<u>BNPM/NCB/SLUDGE DRYER/0905/2020-21</u>	BANK NOTE PAPER MILL PRIVATE LIMITED	
	CORRIGENDUM NO. 1

CORRIGENDUM No. 1, DATED 08.02.2021

**Design, Supply, Installation, Commissioning, Performance Test of Sludge Drying System
with all accessories at BNPMIPL, Mysuru**

**Client: BANK NOTE PAPER MILL INDIA PRIVATE LIMITED, MYSURU,
KARNATAKA**

ANNEXURE A

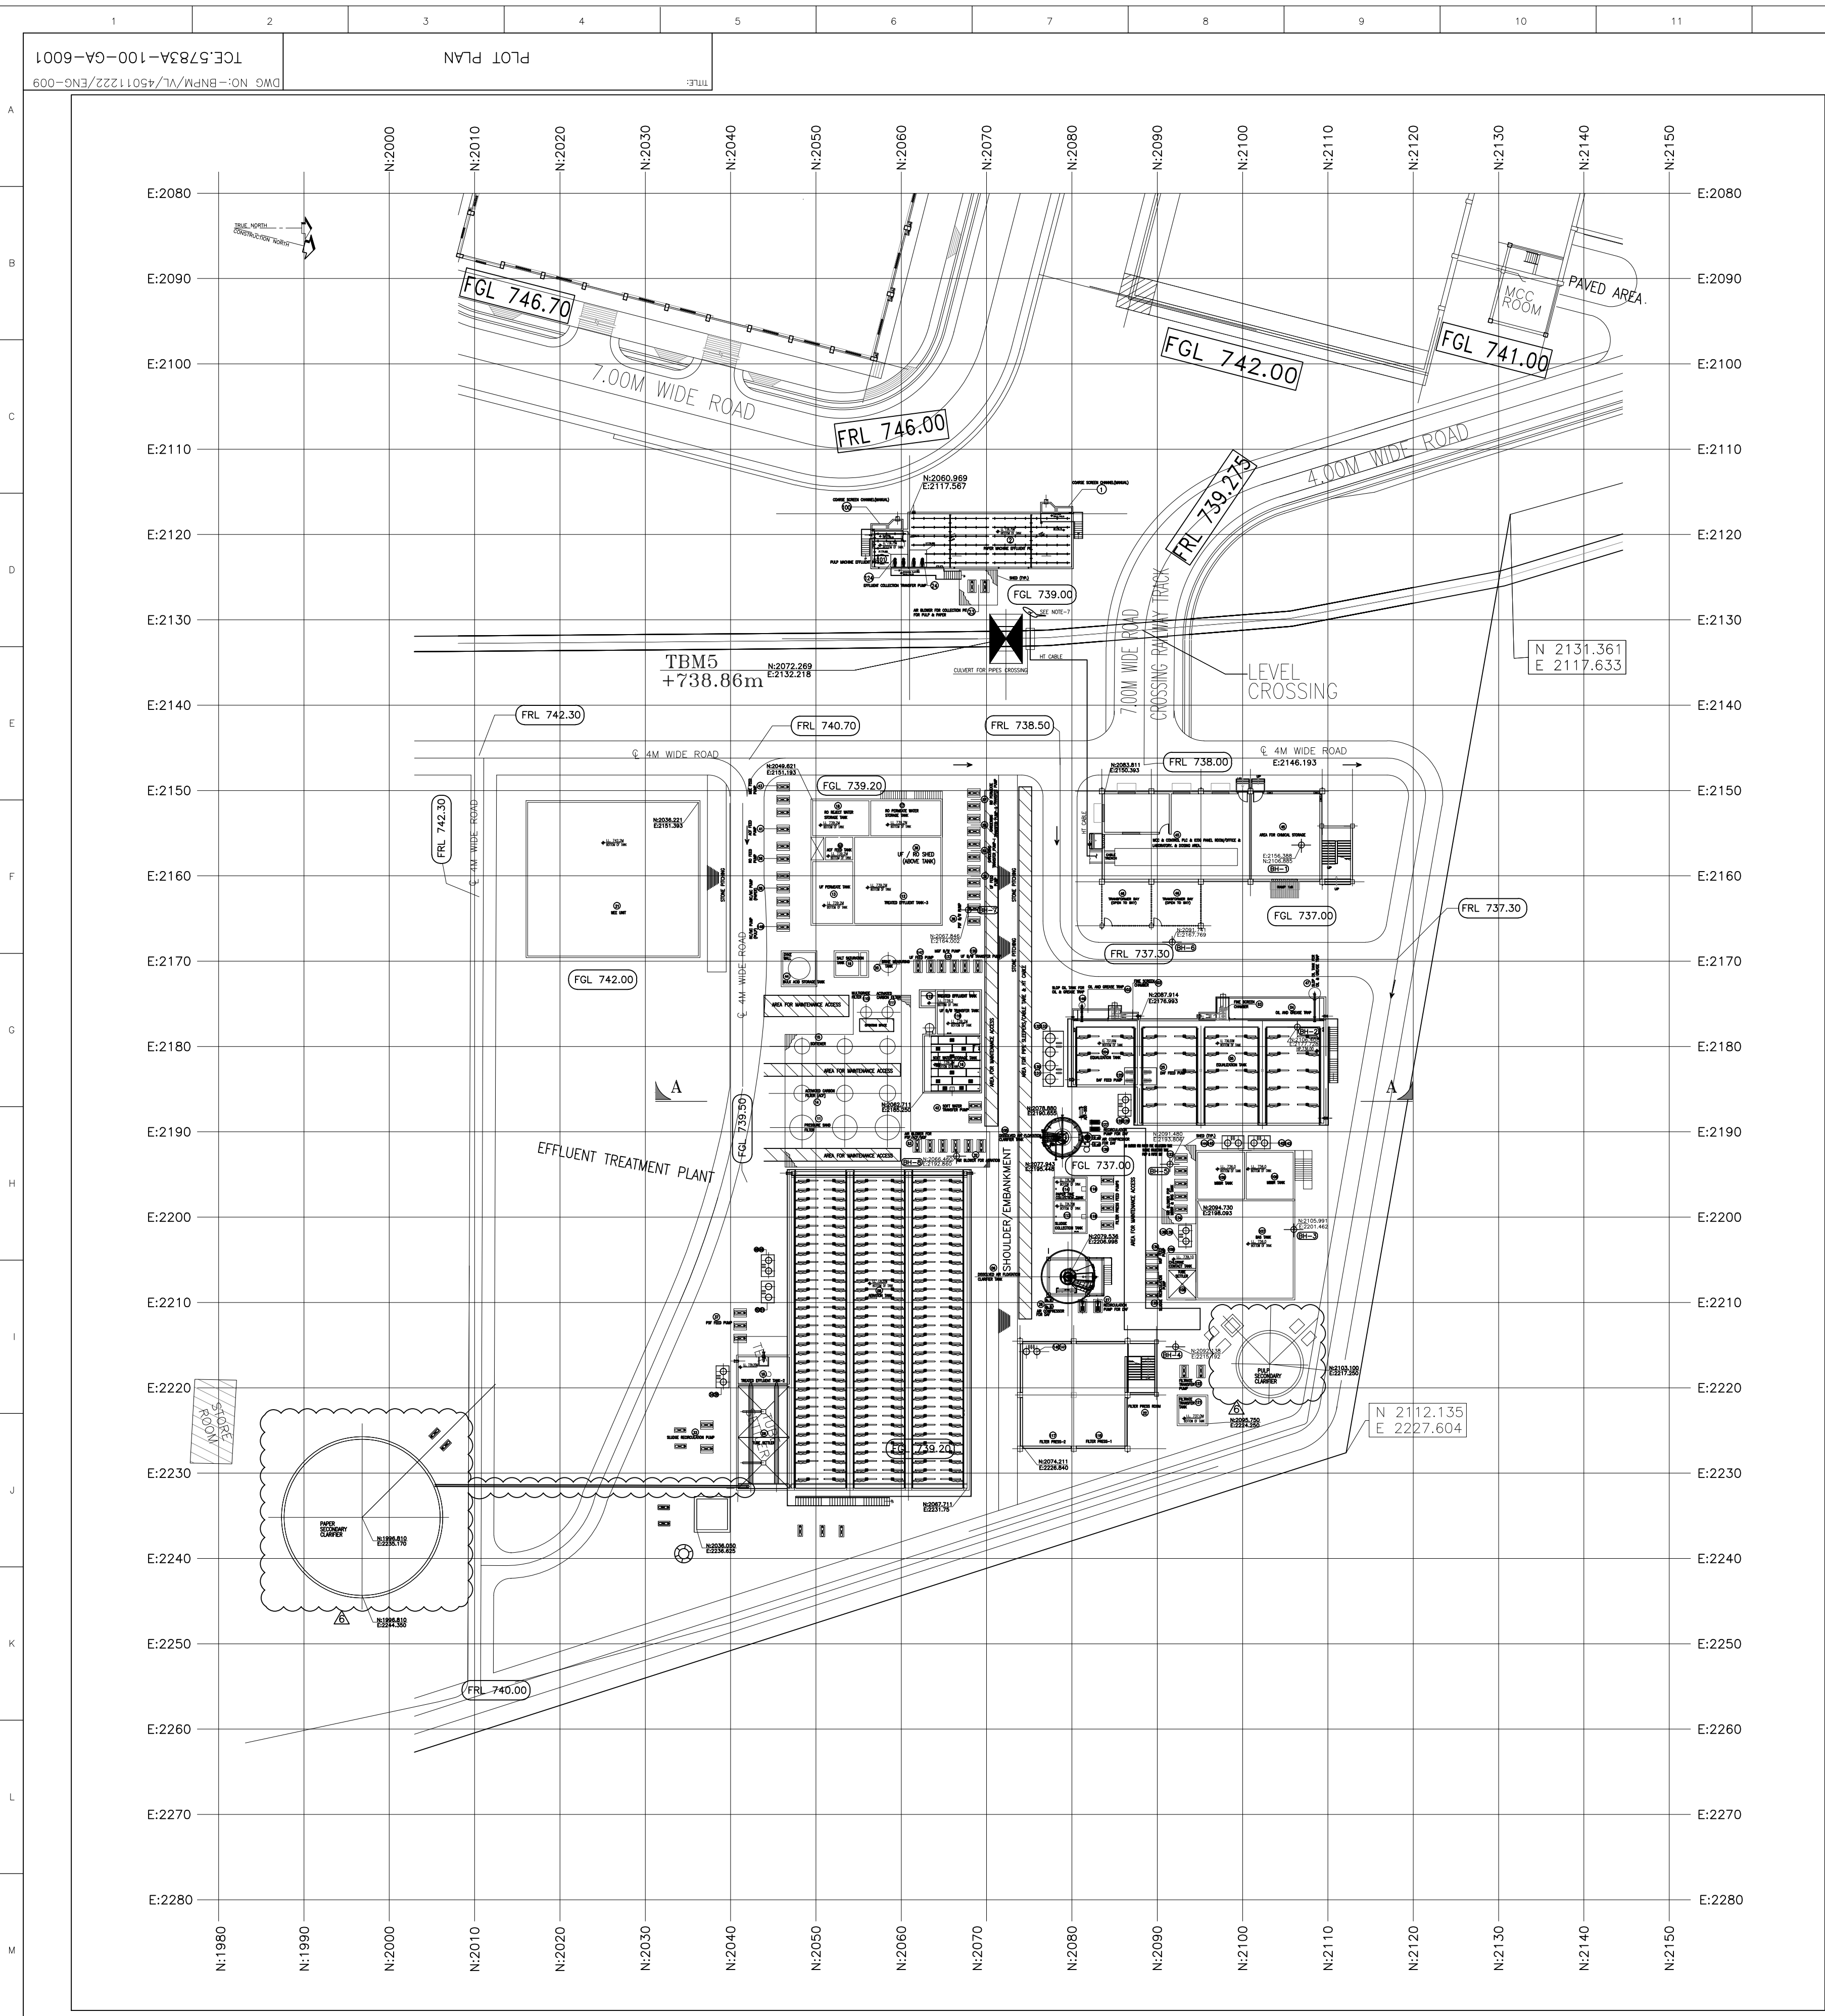
16.	Sec – VII , Technical Specification and Scope of Work	Planned site layout to understand exact requirements is requested. As per provided drawing on page no. 49 how much wide we can use for placing Drying system?	Ref Annexure A: Plant Layout. Bidder may visit BNPM, Mysore site for clarification.

27.	Sec - VII , Technical Specification and Scope of Work	Length and width available for 50 M2 Area is requested	Length x width : 5m x 10m
28.	Sec - VII , Technical Specification and Scope of Work	Key plan area is requested where sludge dryer is to be installed.	Attached as Annexure A. For further clarification, bidder may visit BNPM, Mysore site for any clarification.
